Update of Dialog® User manual for USA and Canada

During the FCC and ISED approval process of Dialog®, ACB has suggested some changes to the submitted version of Dialog® user manual. Novo Nordisk confirms that these changes will be implemented before releasing Dialog® device in the market. These changes are summarized in this document.

Ashwani Kumar
Senior Systems Engineer
Date: 18th November 2021

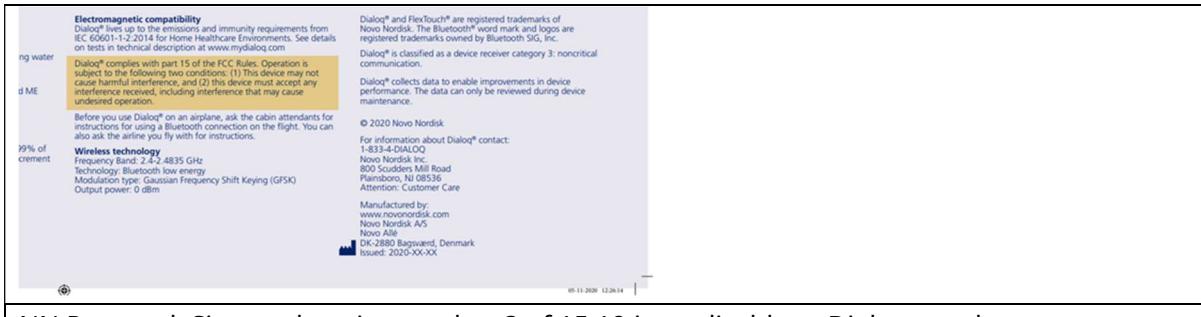
Current NN implementation:

NN Proposal: Since only point number 3 of 15.19 is applicable to Dialoq, no changes proposed as current implementation is sufficient.
